NUCLEAR REGULATORY COMMISSION

Title: ACRS PLR Subcommittee

Date: July 10, 2012

CHAIR SKILLMAN: Good afternoon. This meeting will now come to order. Ladies and gentlemen, this is a meeting of the Seabrook Plant License Renewal Subcommittee.

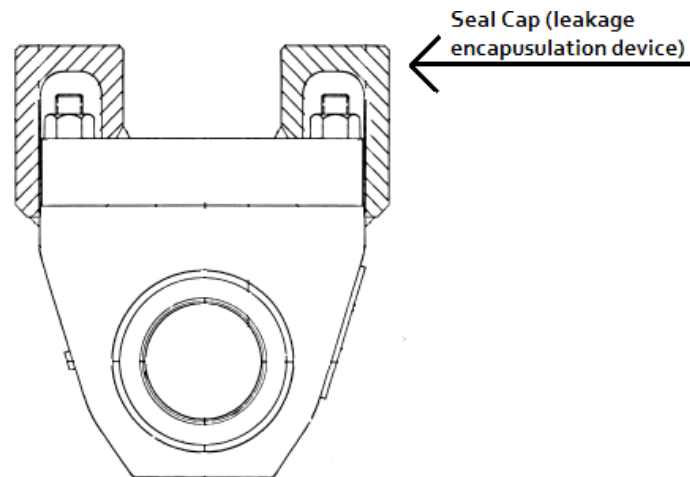
- Once a seal cap enclosure is installed, the bolting and component external surfaces within the enclosure are no longer visible for direct inspection.

- NextEra will remove the seal cap enclosure.

OI 3.0.3.1.9-1

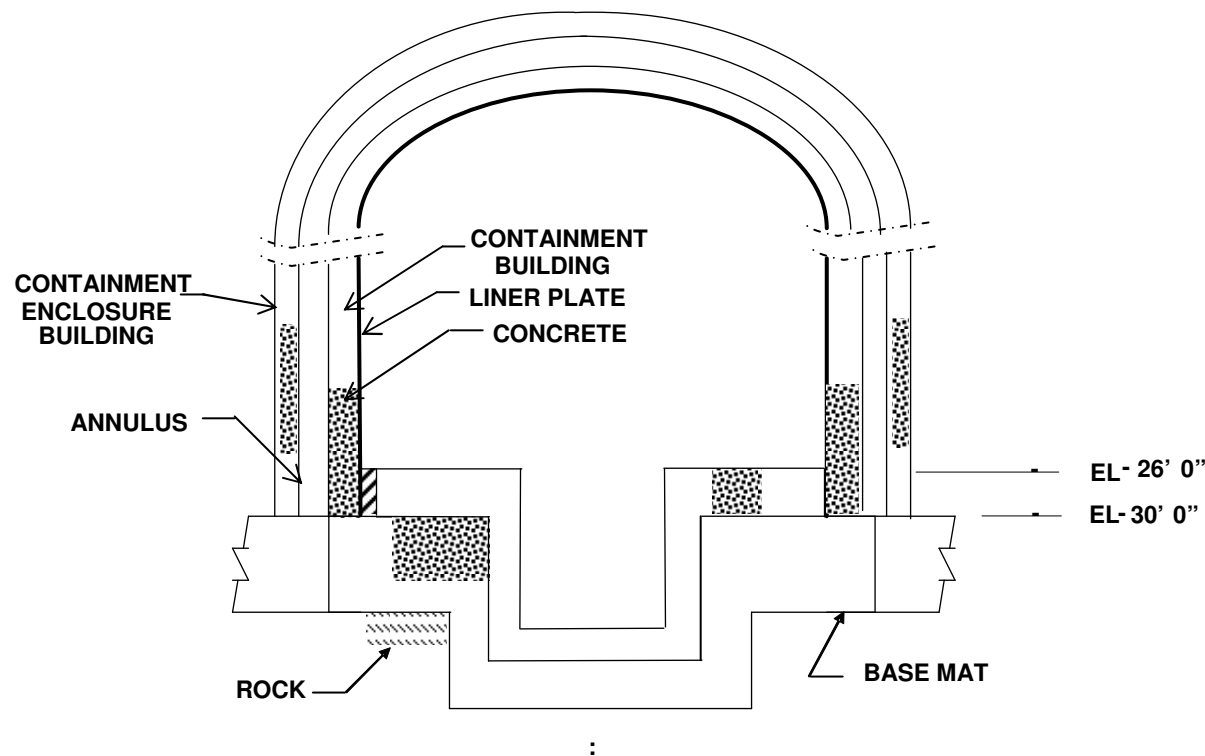
- Accumulation of water in the Containment Enclosure Building annular space can potentially degrade the containment liner plate.

OI 3.0.3.2.18-1

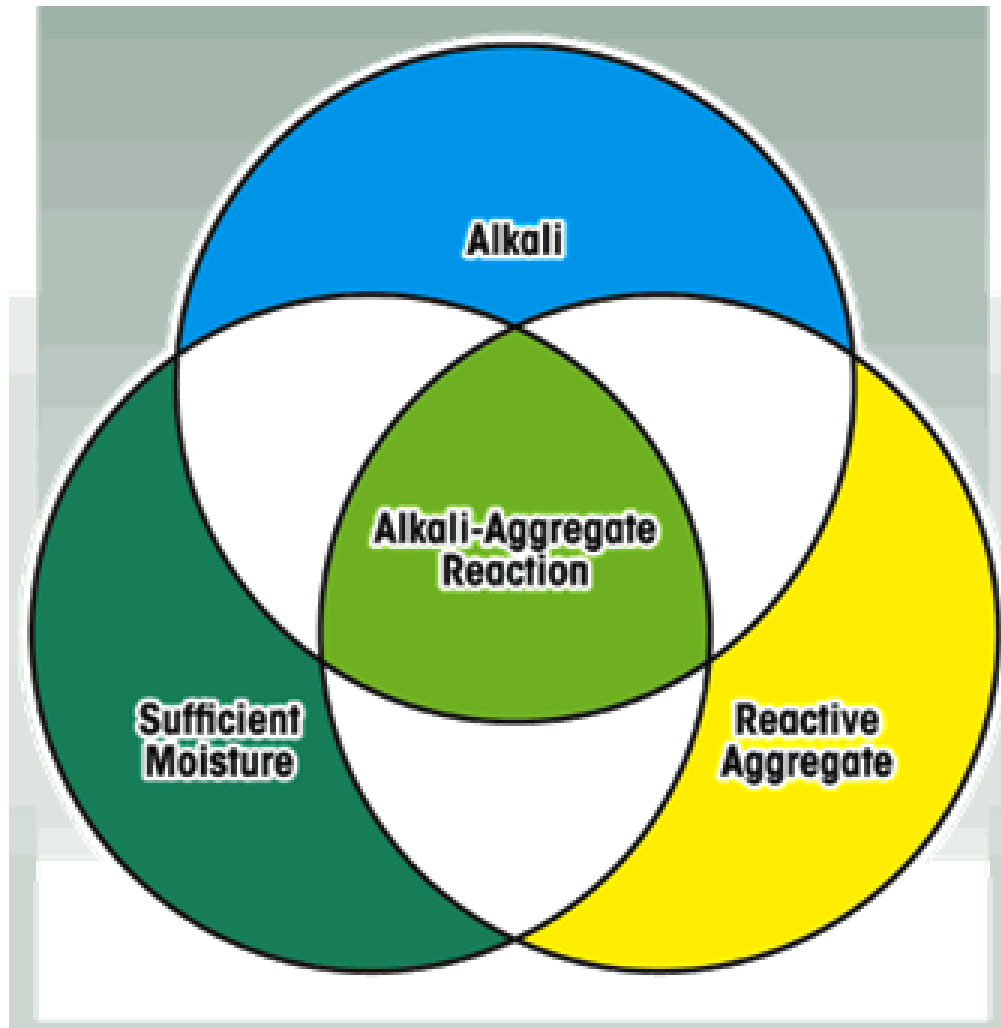
- The applicant's enhancement to the Structures Monitoring Aging Management Program is not sufficient to manage the effects of ASR
- The applicant has not enhanced the containment IWL program for ASR
- The applicant submitted an ASR monitoring program (May 16, 2012)
